Notice of Allowability

10/751,182

YABUSAKI, KENICHI K.

EXAMINER'S AMENDMENT

Fig. 2

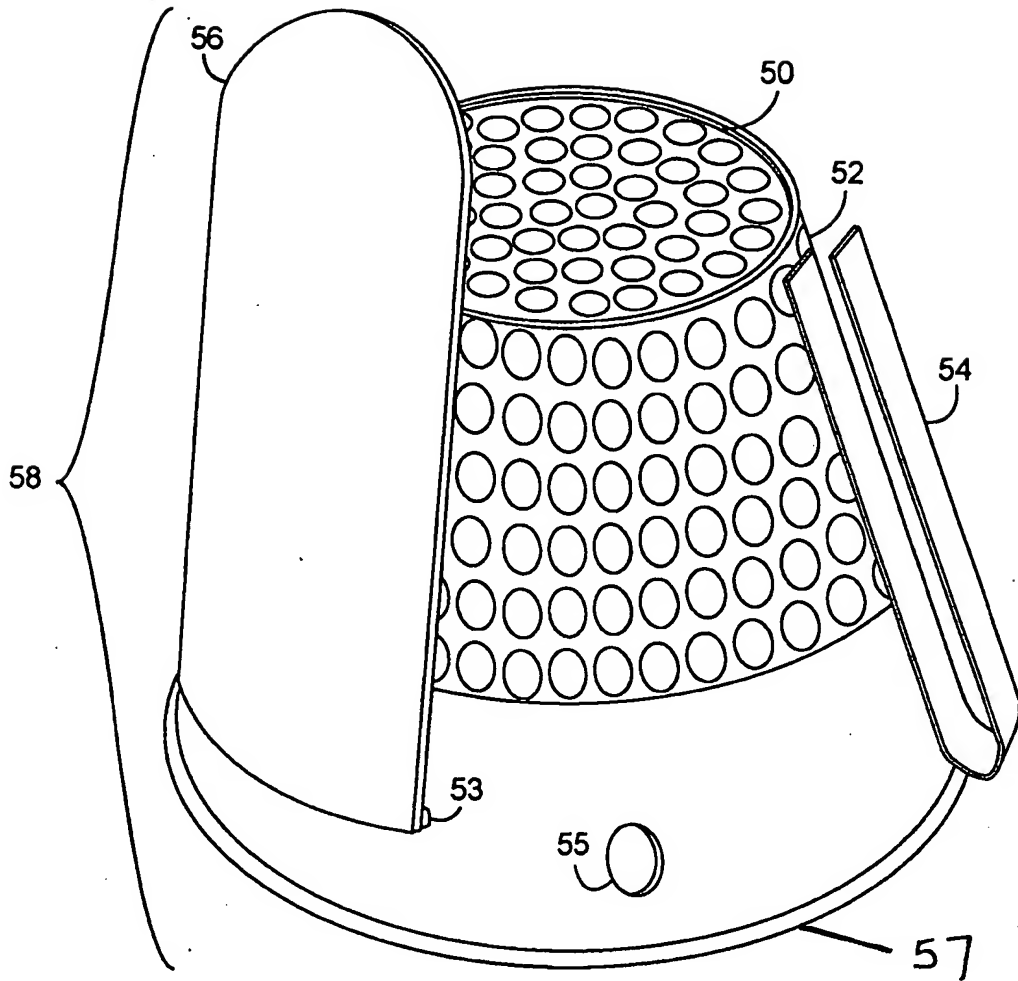
2. The following changes to the drawings have been approved by the examiner and agreed upon by applicant: inserted no. 57 into Fig. 2 to denote the large end and inserted nos. 67 and 69 to denote the one end of the attachment strip and the another opposite end of the attachment strip in Fig. 3. In order to avoid abandonment of the application, applicant must make these above agreed upon drawing changes.

*Drawing Convention Approved
DWA 9/15/05*

Fig. 3

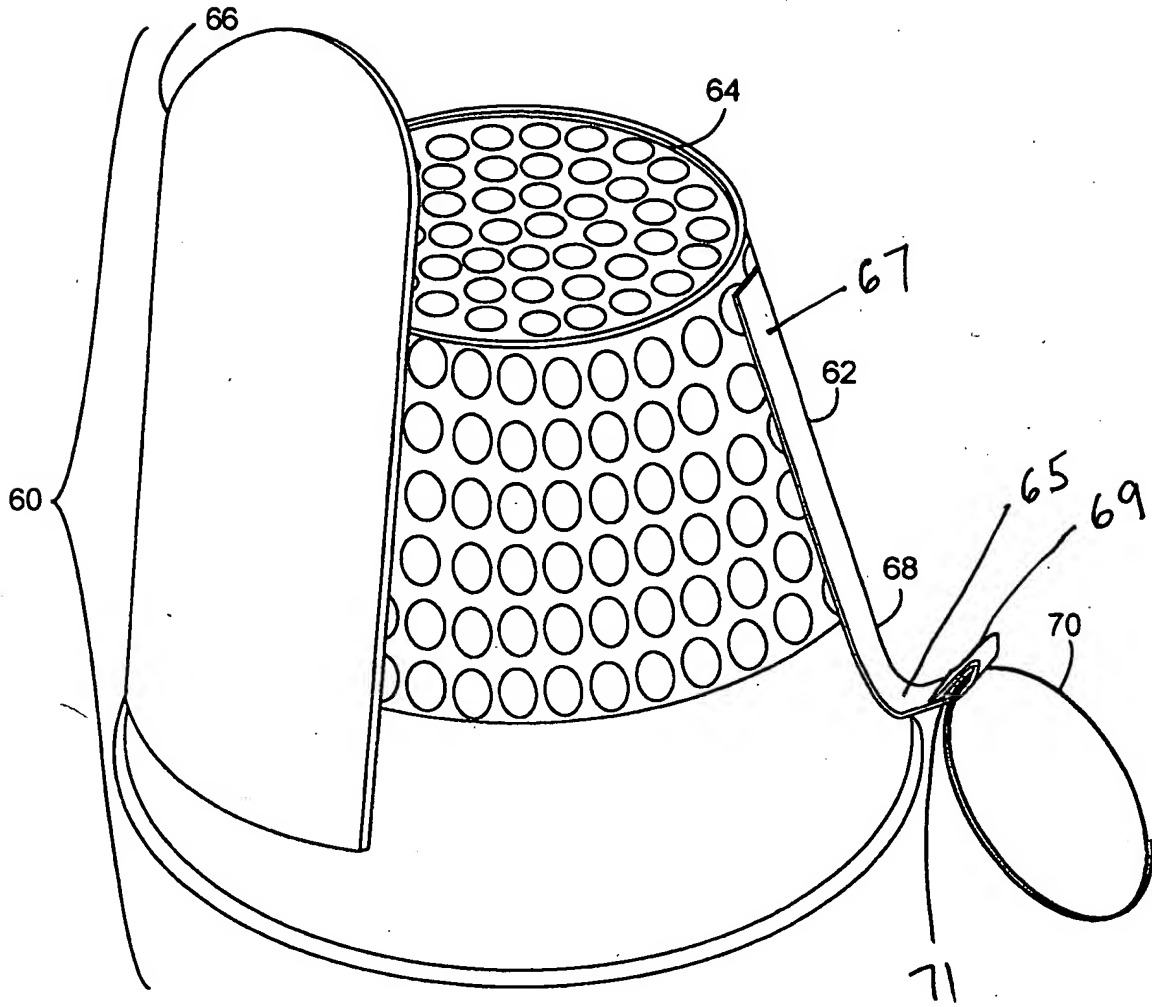
*Drawing Creation Approved
DWA 9/15/05*

Page 7, line 23, inserted -- The attachment strip 68 is attached in abutment to the body 62 at one end portion 67 and has an opposite end portion 69 which extends outwardly away from the body 62 and wherein there is a bend 65 in the attachment strip 68 between the one end portion 67 and the opposite end portion 69. The one end portion 67 is a planar surface which is attached to an outer surface of the body 62. The opposite end portion 69 extends from the bend 65 in a cantilevered manner. The loop 70 is pivotally attached to the opposite end portion 69 through an aperture 71 in the opposite end portion 69.-- after "to the body 62".
